This letter is intended to address the issue of warning notes on 7' jack trusses. I have reviewed the jack truss and it passes without modification for any jack up to 7' with a total loading not to exceed 55# and a maximum overhang of 2'. Below is a copy of note you will see on the jack. This letter will act as an approval for the truss mentioned above.

Job 300029	Truss CJ1	Truss Type JACK	Qty 14	Ply 1	HOUSECRAFT - FARRIMOND RES. 300029001 Job Reference (optional)
Builders FrstSource, Lake City, FL 32055			7.110 s Dec 8 2008 MiTek Industries, Inc. Wed Mar 11 14:53:57 2009 Page 1

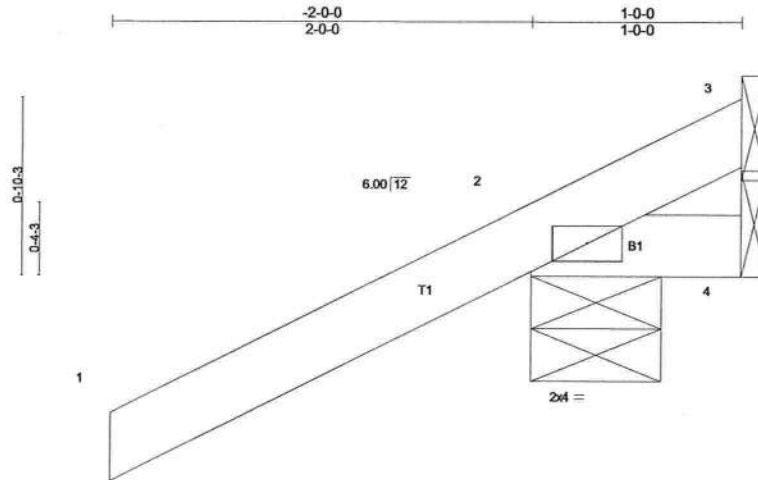
*****Design Problems*** Review Required/ Max Deflection In Panel Exceeded: A-B**

Job 300029	Truss EJ7	Truss Type MONO TRUSS	Qty 31	Ply 1	HOUSECRAFT - FARRIMOND RES. 300029007 Job Reference (optional)
Builders FrstSource, Lake City, FL 32055			7.110 s Dec 8 2008 MiTek Industries, Inc. Wed Mar 11 14:54:01 2009 Page 1

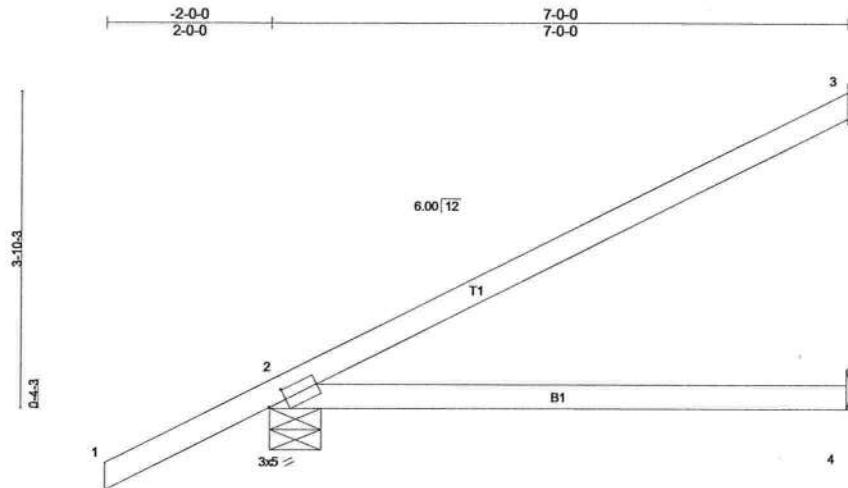
***** Design Problems *****
REVIEW REQUIRED
Max Deflection In Panel Exceeded: 2-3
